Plan Change Request

Site Address/ Parcel #: 1023 39TH AVE SE Permit #: PRCCP20240183
Owner: Benaroya Capital Email: davev@benaroya.com
Design Engineer: Cara Visintainer Email: cvisintainer@barghausen.com
Contractor: Howard S Wright Email: jlane@HSWC.com

➤ Specify the approved civil plans affected: C1, C6, C7, C11, C14, C15, C17, C19, C20

COVER SHEET
FOR
CENTERIS VOLTAGE PARK

SOUTH UTILITY YARD SEWER BLOW-DOWN PLAN
FOR

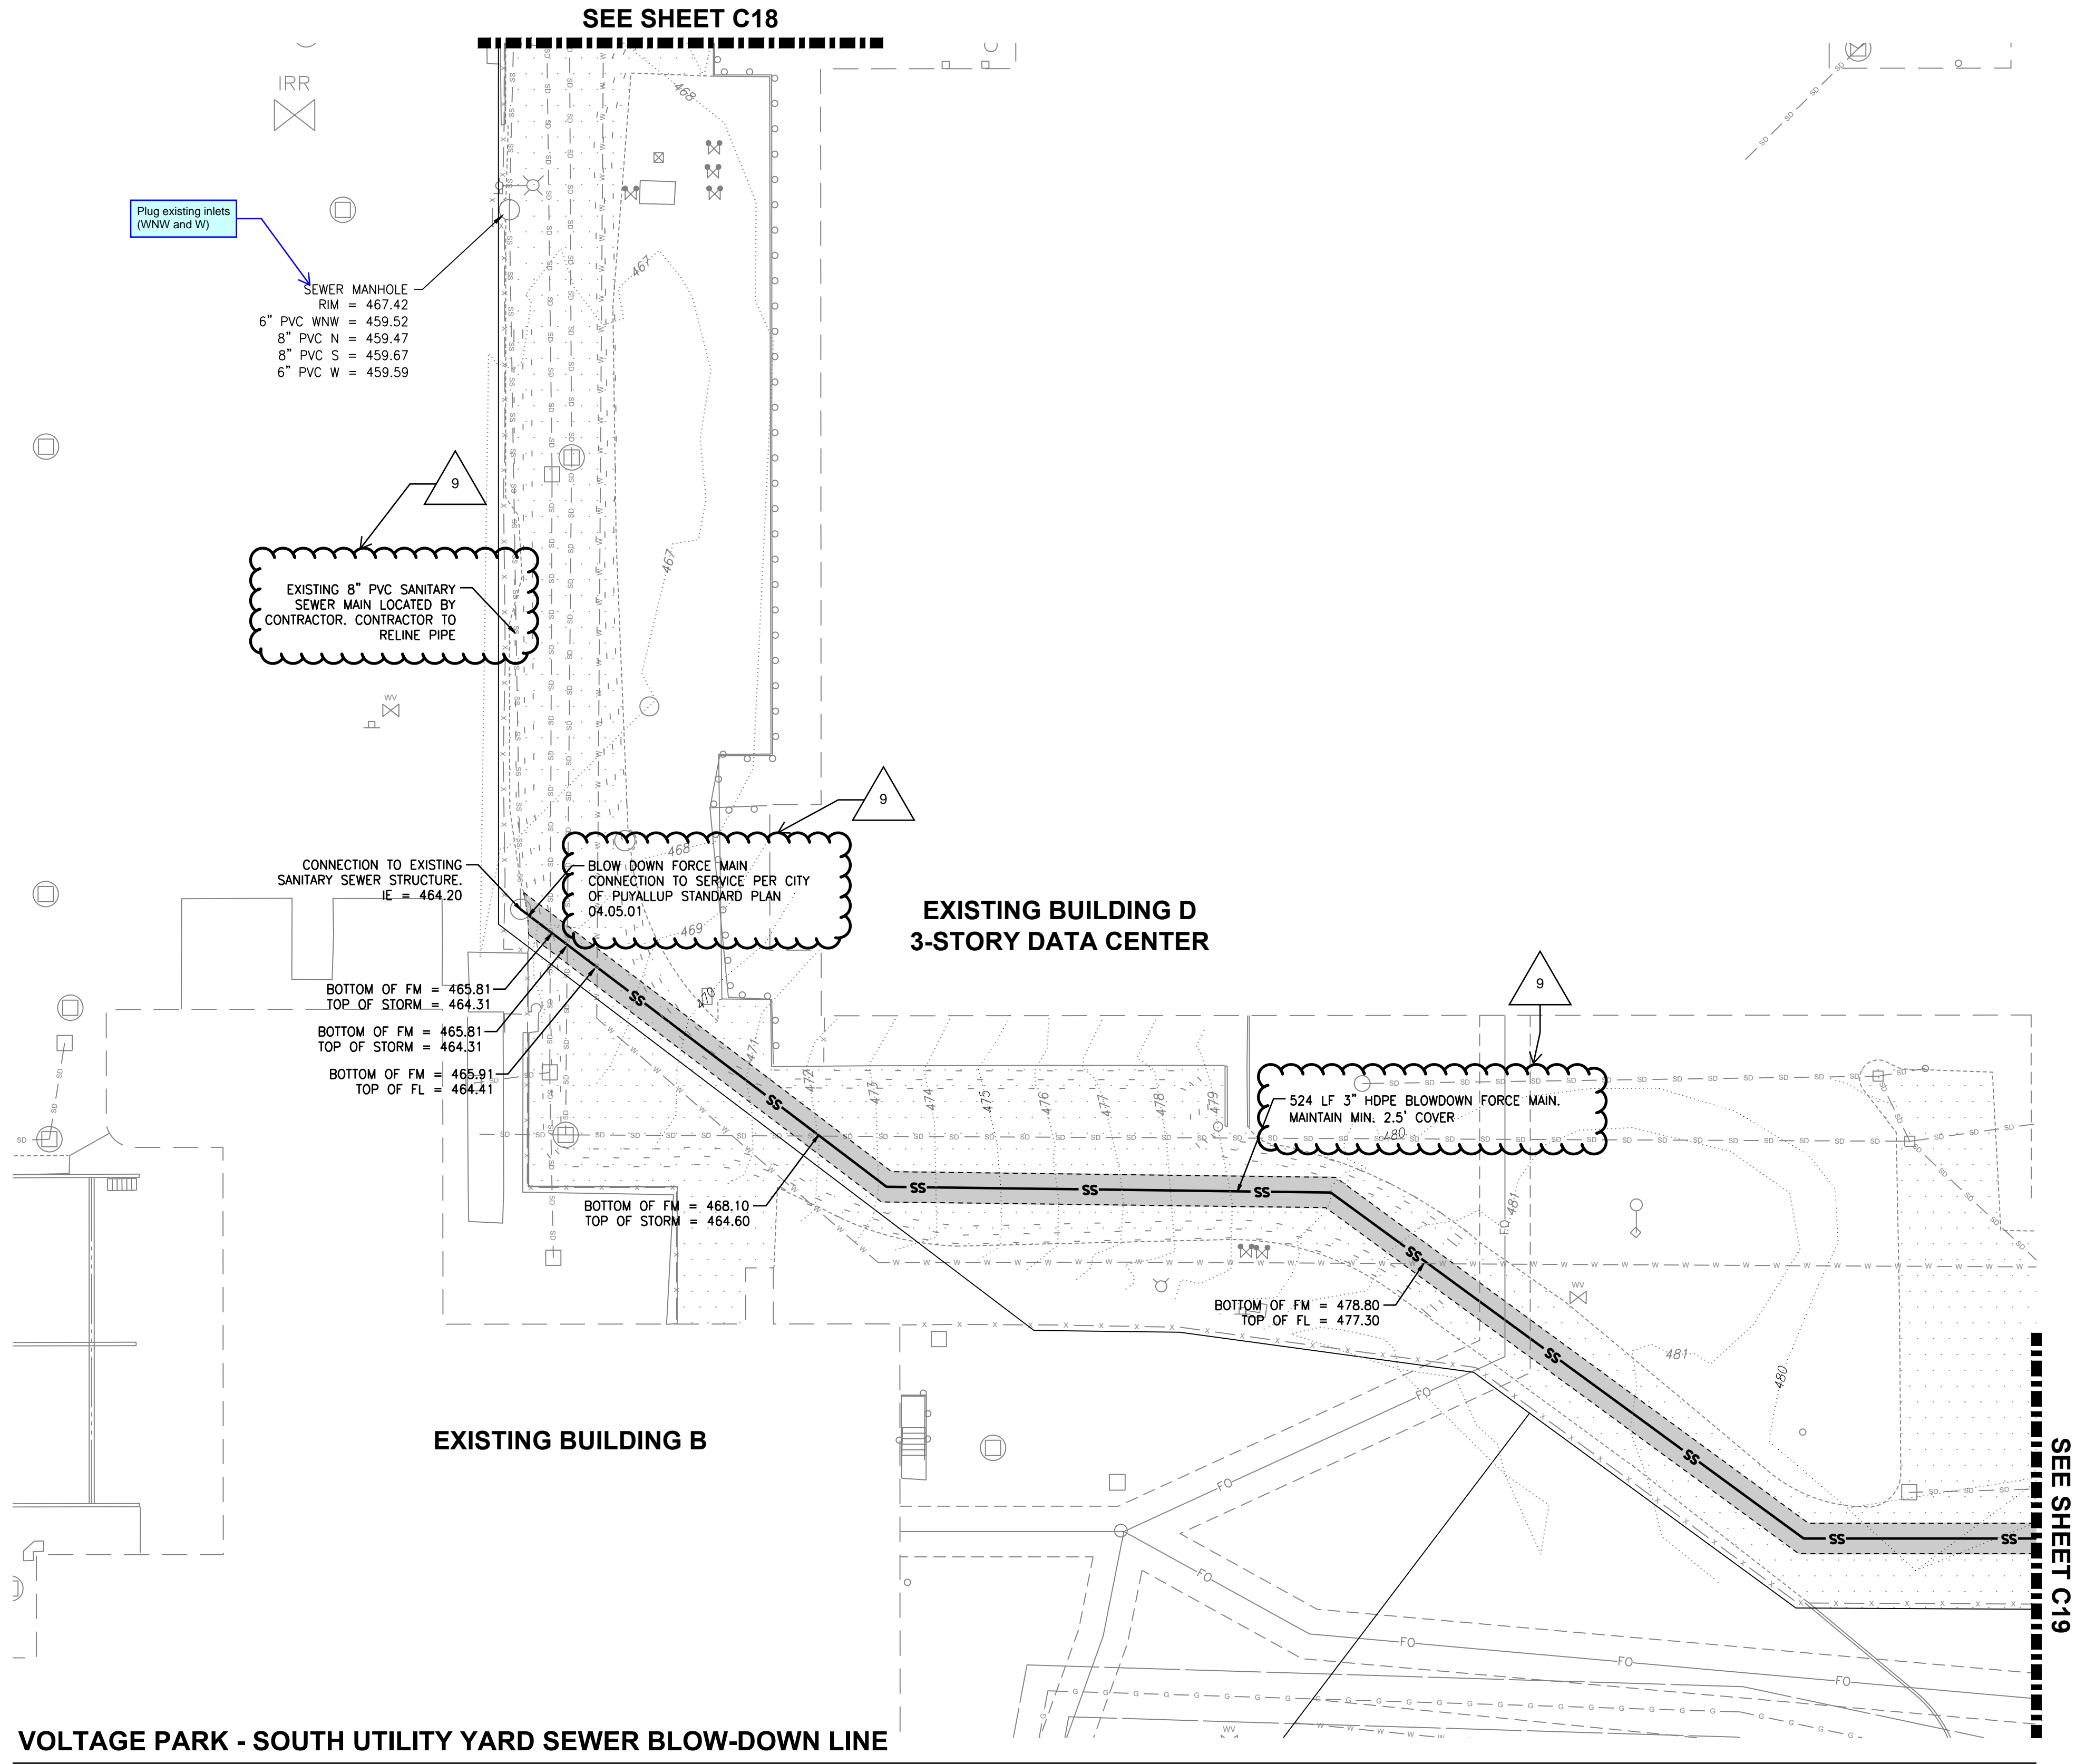
***SEE COMMENTS ON SHEET C18 and C20.
